# Service Bulletin

Bulletin No.: 20-NA-198

**Subject: Trailer Running Lights Shut Off Due to Excessive Load on the Running Lamp Circuit**

5652571

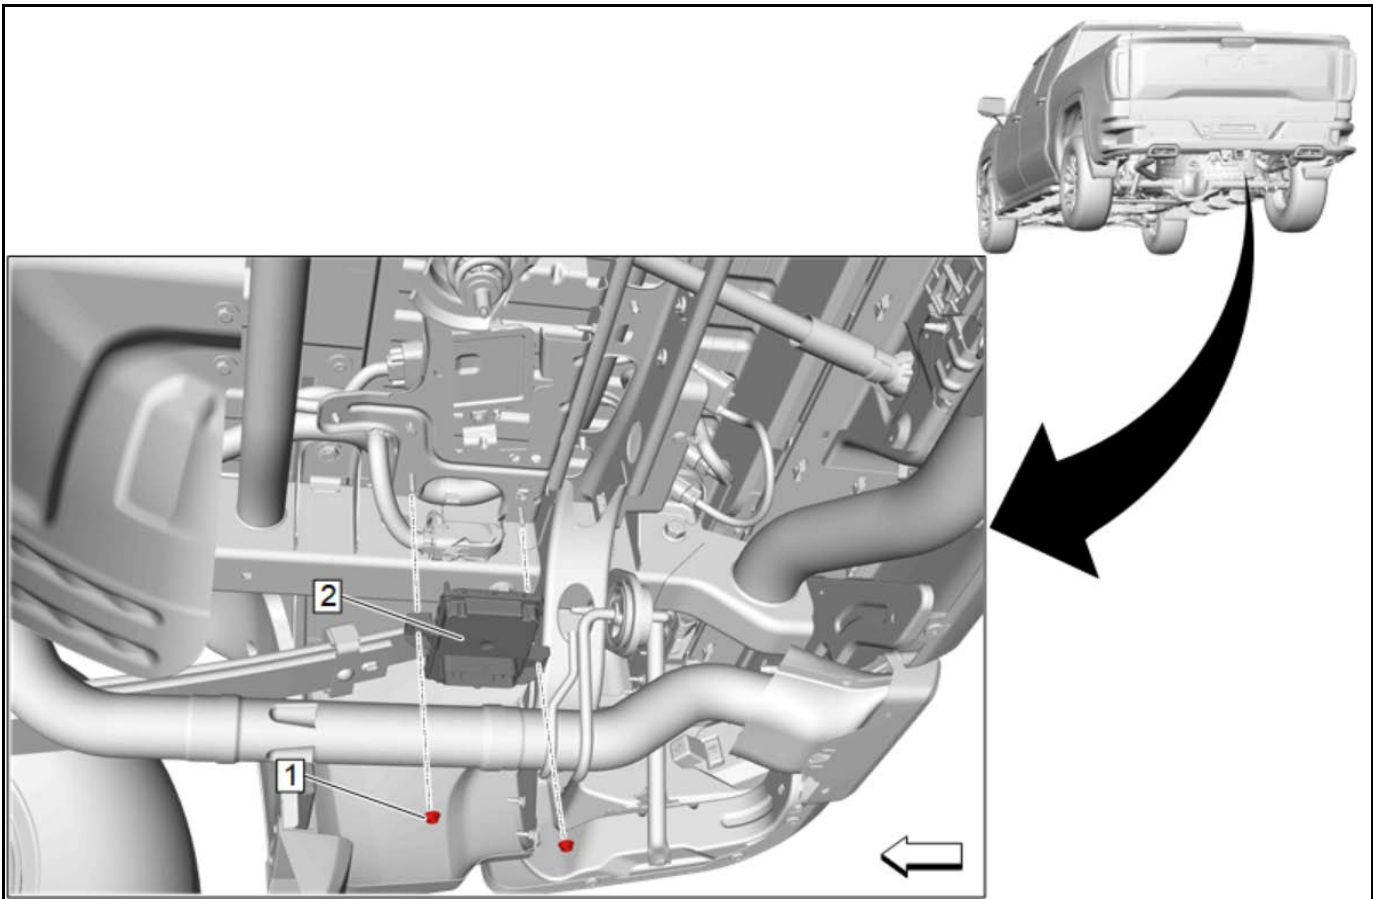
**For 2019 models ONLY**, Follow the steps in the Service Procedure below, and move circuit 2109 on the Trailer Lamp Control Module from X1 cavity 5 to X1 cavity 25, and install new Trailer Lighting Module.  
**For 2020 — 2023 models ONLY**, No wiring changes are required. Confirm the Condition, Plug in a new Trailer Lamp Control Module, confirm the issue is fixed.

5209978

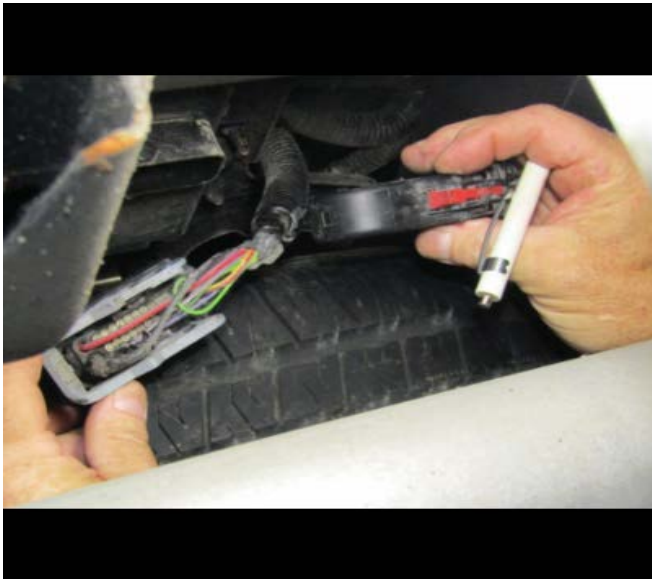
3. Locate the Trailer Lamp Control Module (2) and disconnect the chassis harness X1 electrical connector.

5652576

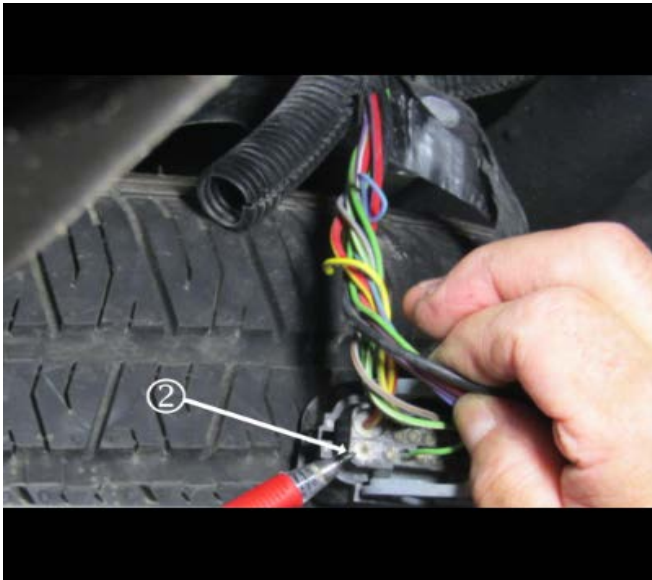
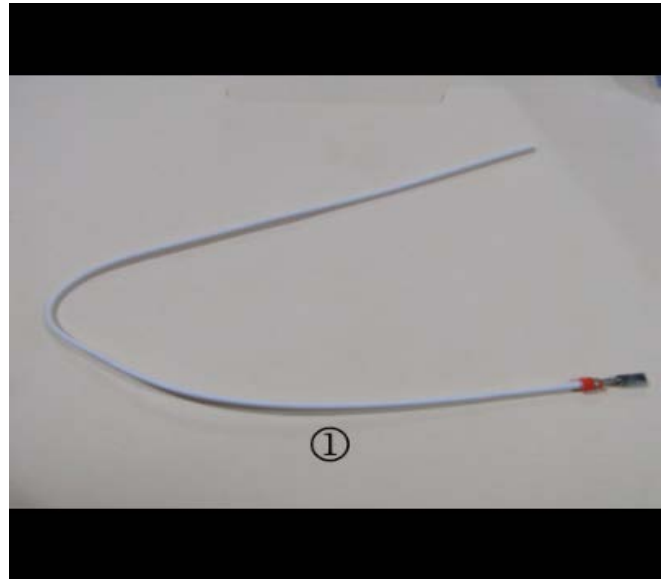
6. Locate the Gray/Brown wire, at pointer (1), connected to cavity 5, and cut the wire approximately 7.62 cm (3.0 in) from the connector body. The wire will be re-located to cavity 25 (2).

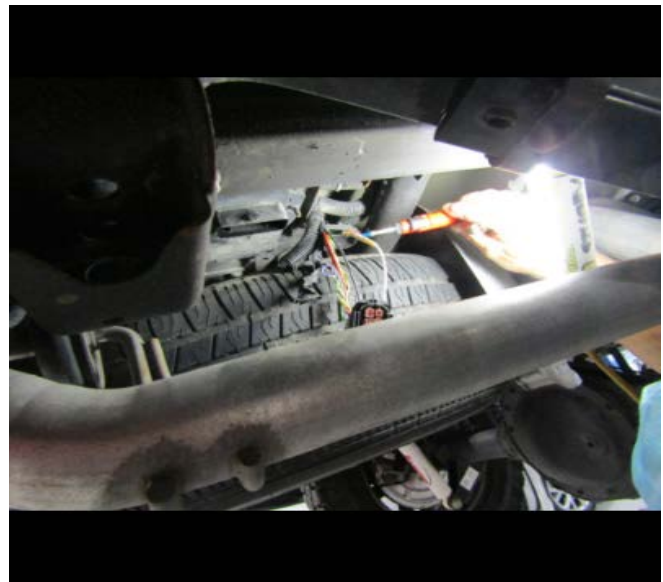
8. Remove the seal from connector cavity 25 and install the new terminated lead (1) into this cavity. Ensure the terminal locks into place by pulling back gently on the wire.
